Burlington Design Advisory Board

DESIGN ADVISORY BOARD

MEMORANDUM

To: The Design Advisory Board
From: Ryan Morrison, Associate Planner
RE: 323-325 College Street
Date: July 26, 2022

Existing Conditions Plan of Land

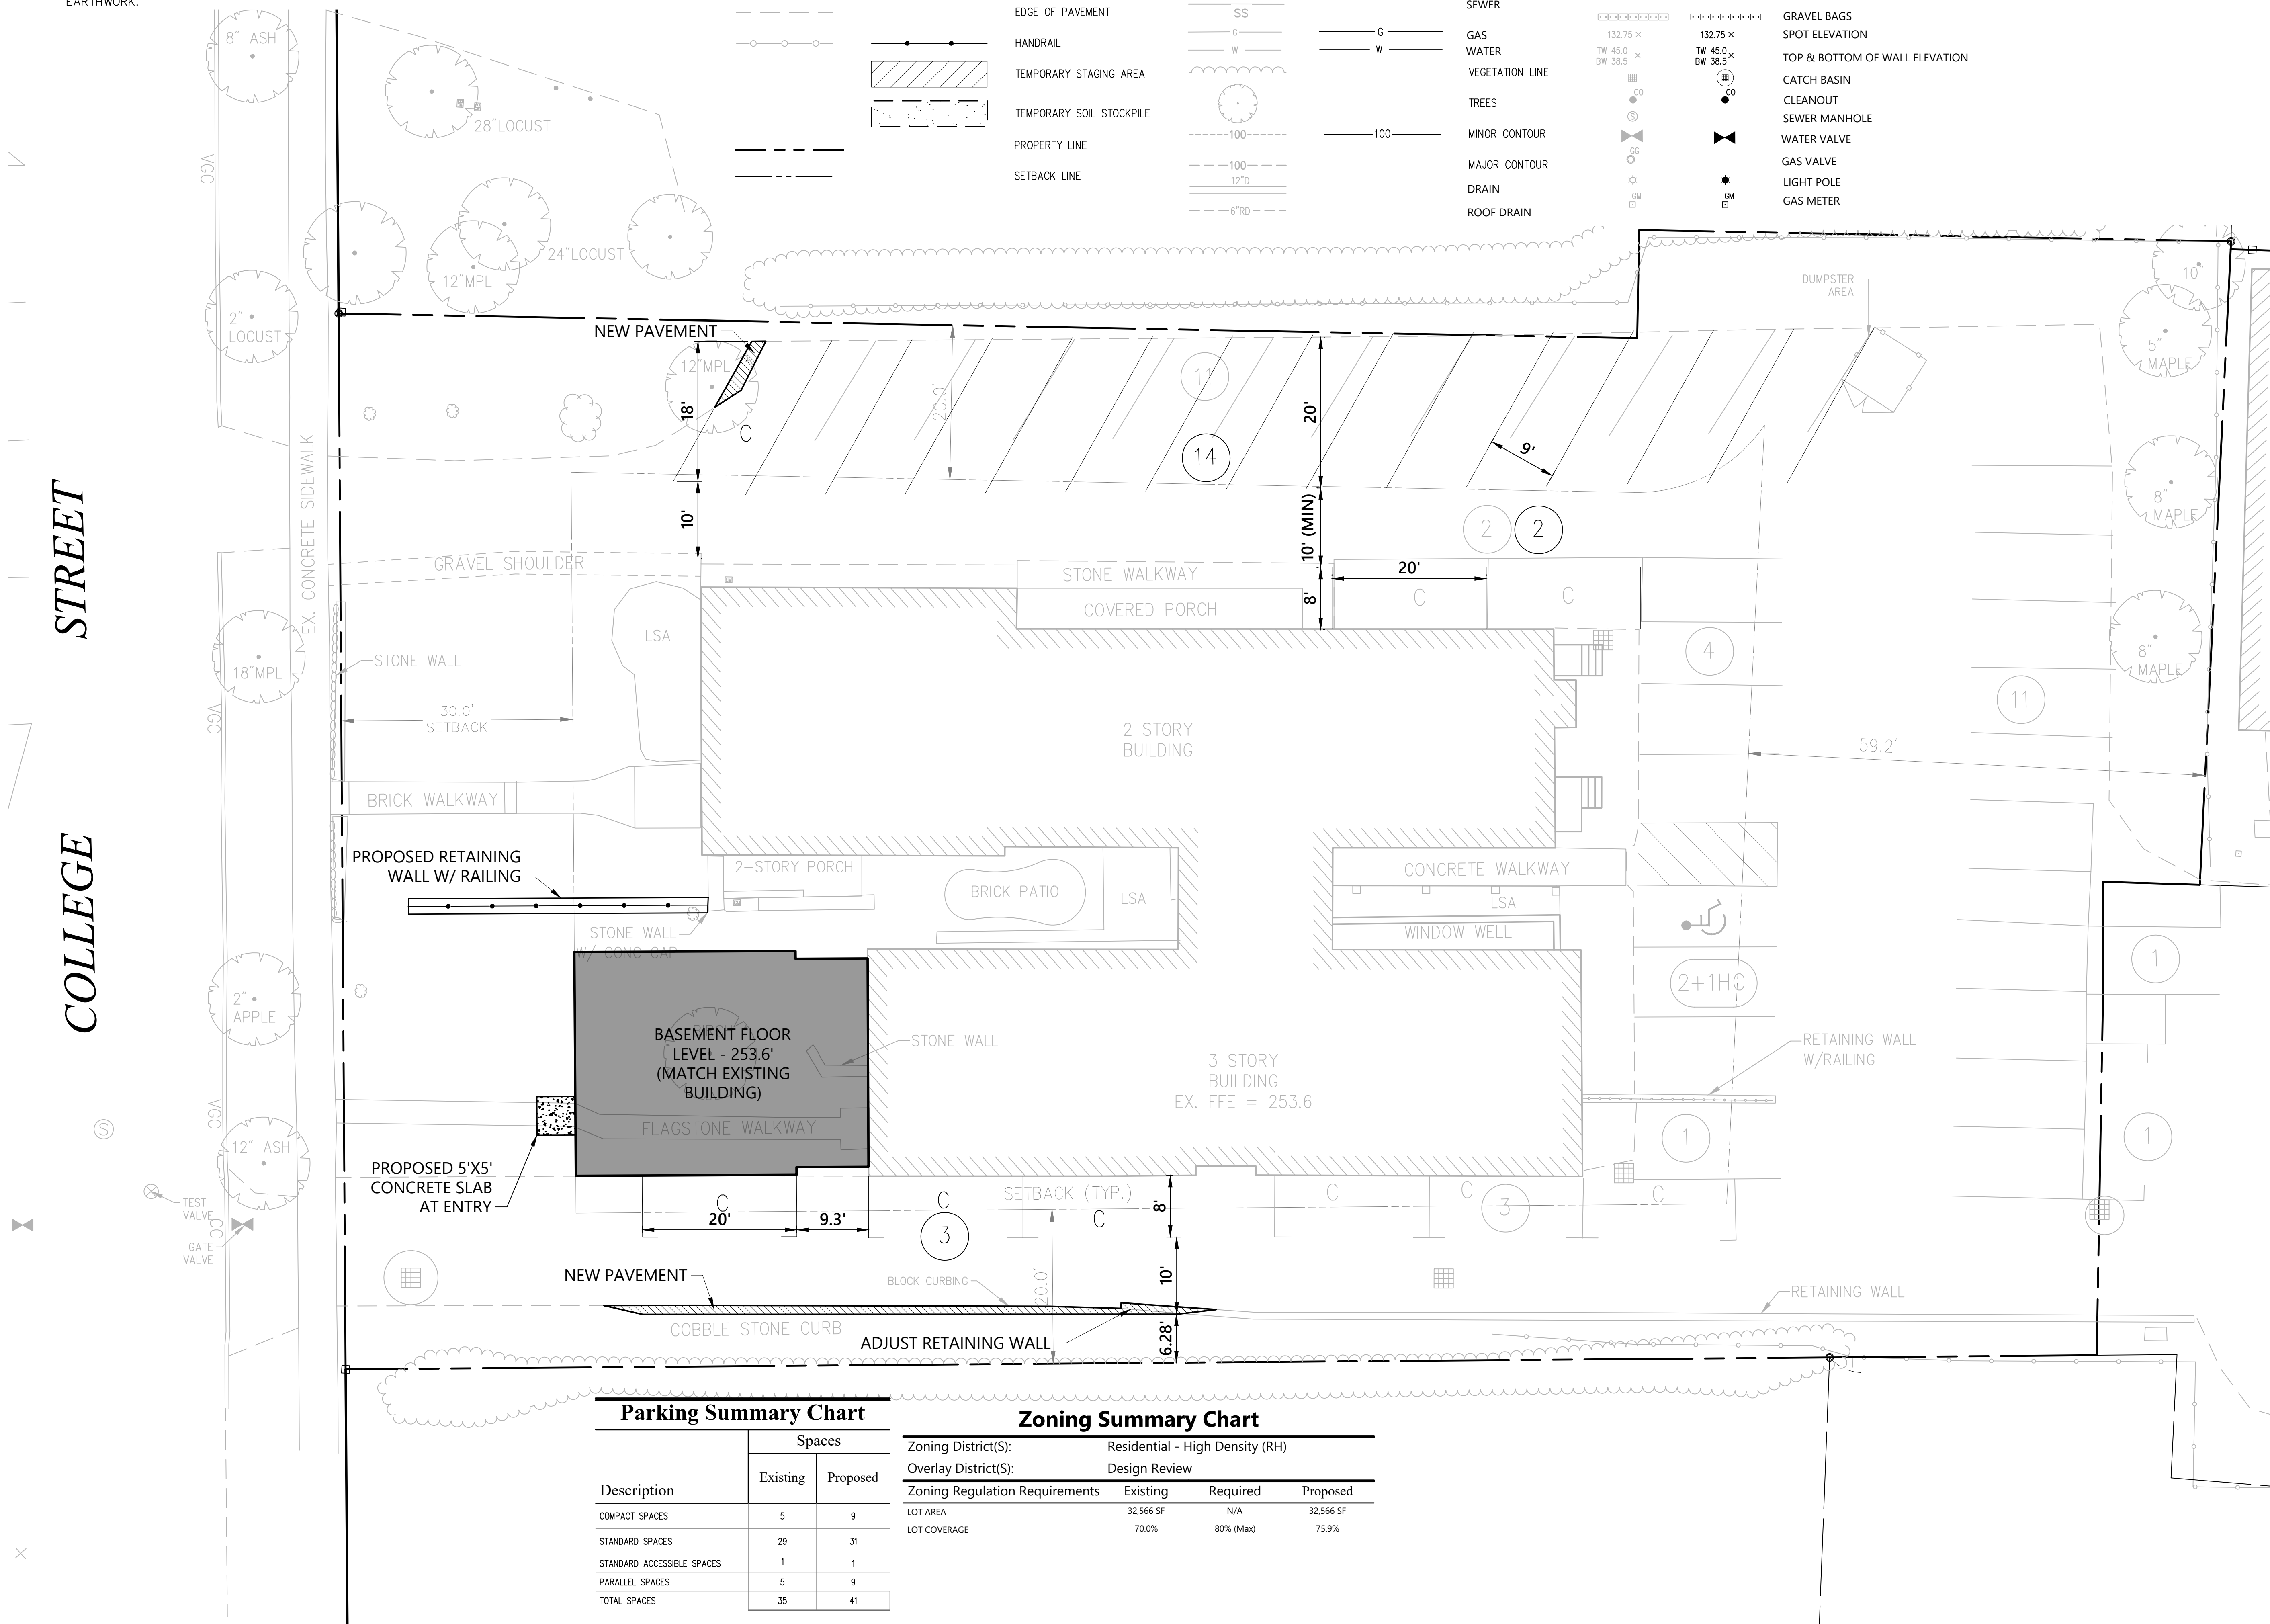
Plan Sv-1 shows a birch tree in the location of the proposed addition which will be removed. No other alterations to natural features are included.

**Layout and
Materials Plan**

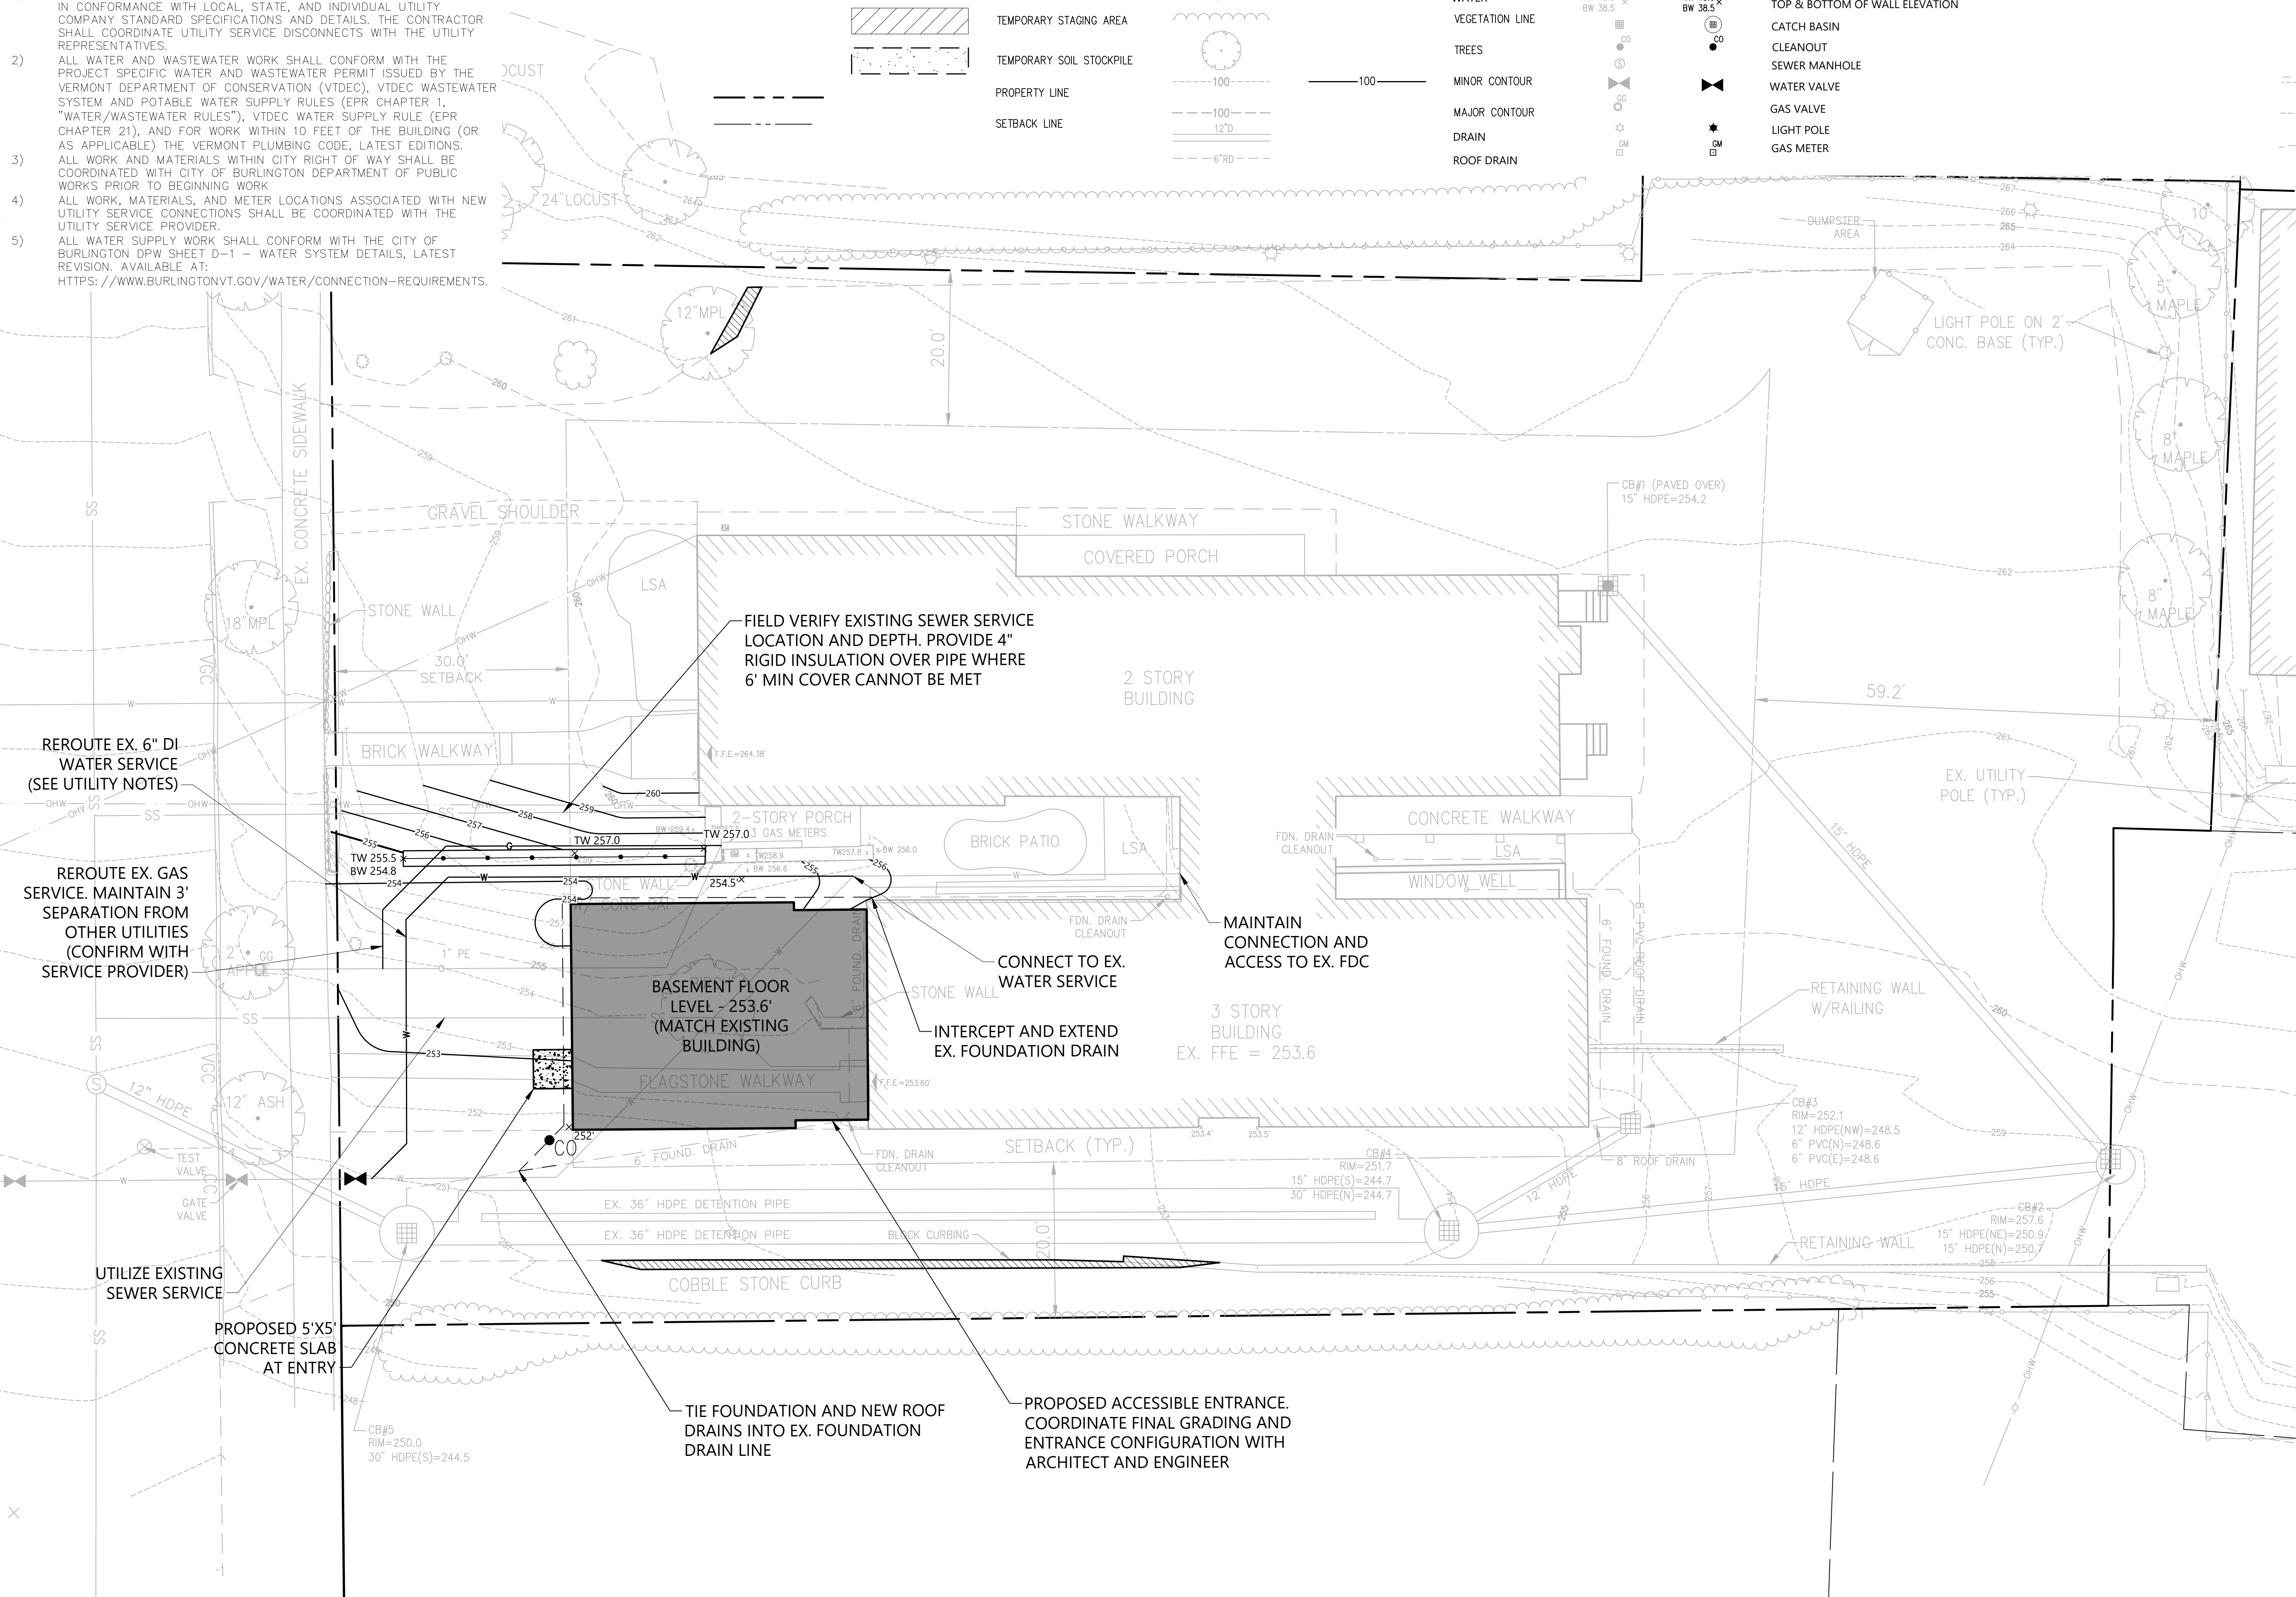
A walkway is illustrated from the public sidewalk on College Street to the new entrance on the street facing side of the addition (Plan C1.01.) The westerly entrance immediately abuts the new parallel parking spaces. The area (9.3' in width) should be appropriately marked as a pedestrian entry, clearly marked by differentiated ground materials and/or pavement markings.

The applicant needs to define any changes to the landscaping, including tree removal with the proposed new addition. Plan C1.01 illustrates a retaining wall with a railing. More information will be required for review. Any retaining wall over 3' requires approval of the City engineer.

8. The applicant shall provide further information about the new retaining wall and the fence, as well as more definition about what "adjust retaining wall" means. (Plan C1.01)

Site Grading and Utility Plan

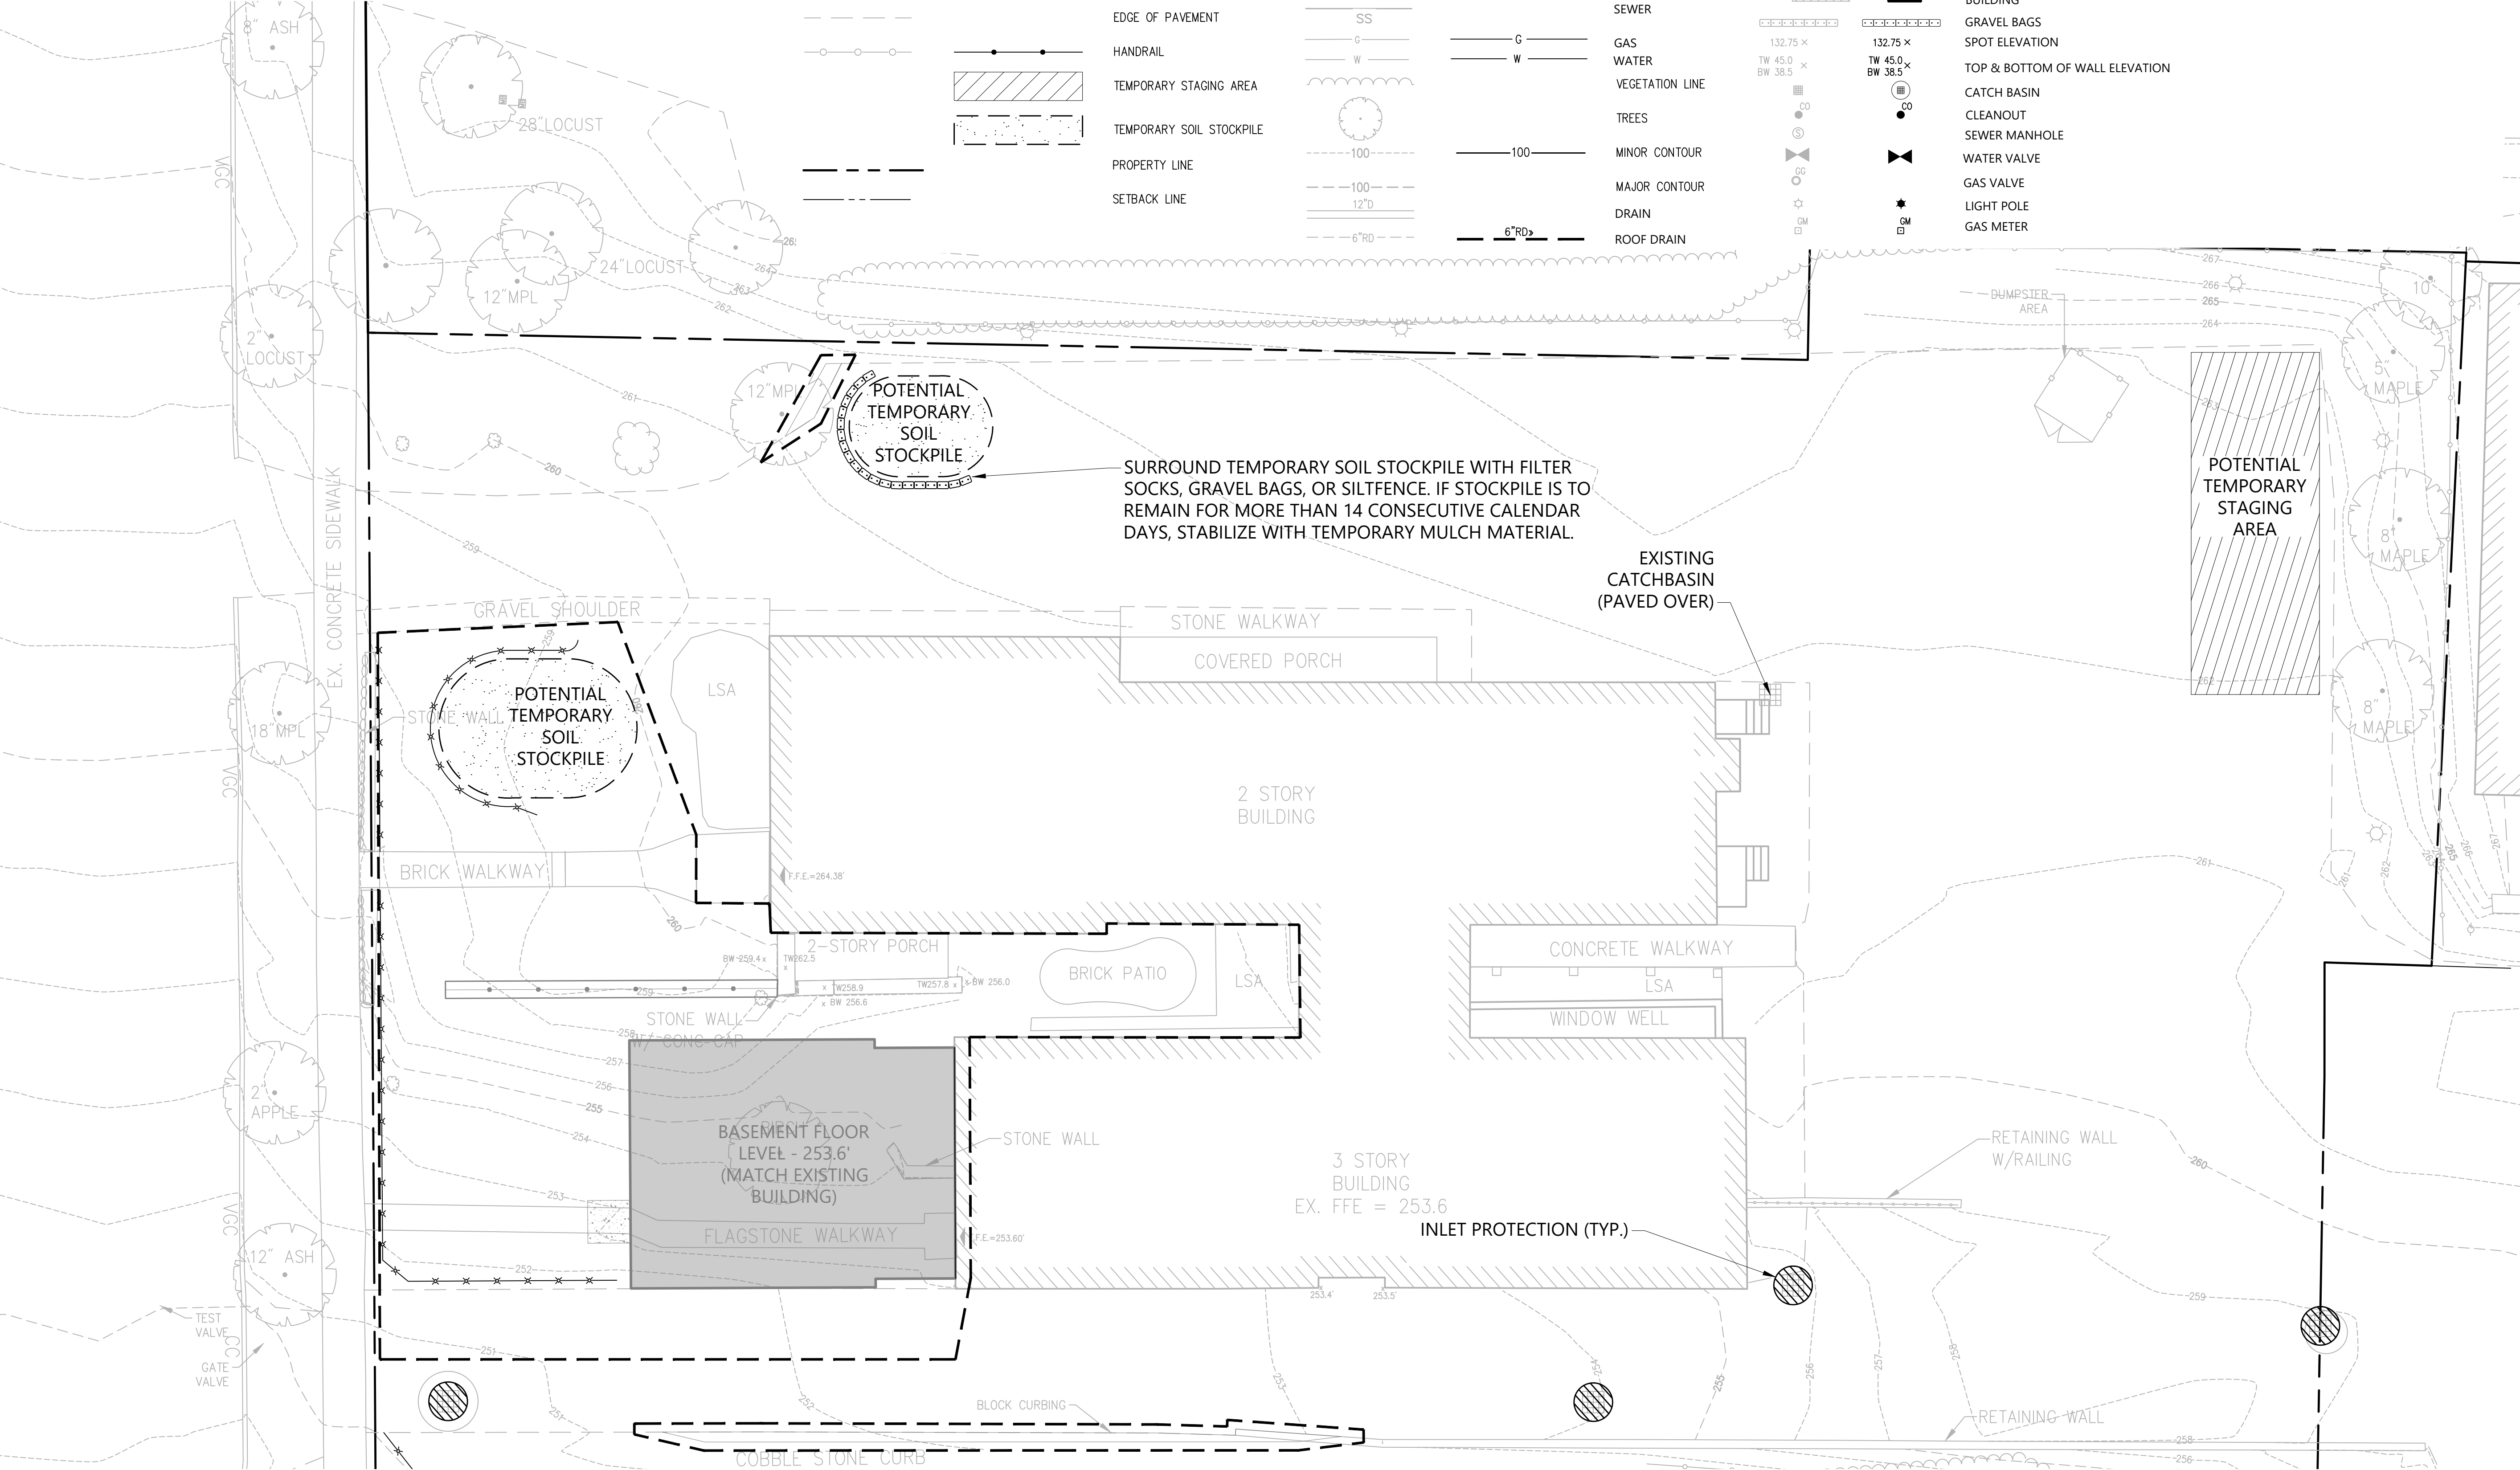
The applicant includes a plan for minor grading to accommodate the addition. The site grading and utility plan are C2.01.
